Title	Cavity Floor Cracking on Gas Oven Range Models		
Create Date	March 10 th , 2017	Service Bulletin Number	ASC20170310001
Revision Date		Models	All Gas Range Models
Symptom	Design	Interior Design/Damaged/Discolor	Cavity Damage

Issue:

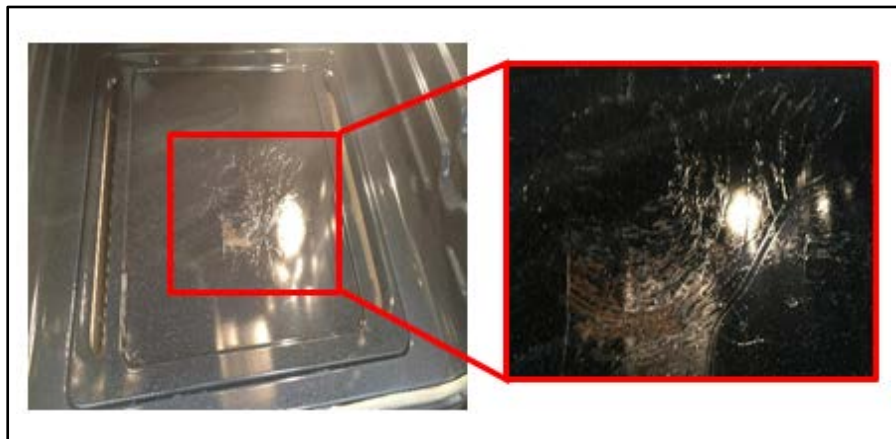
If the bake spreader comes in direct contact with the floor panel, over time, the oven floor coating may start to crack and peel.

The bake spreader has been modified to prevent contact with the floor panel. To resolve the issue, replace the bake spreader and the floor panel.
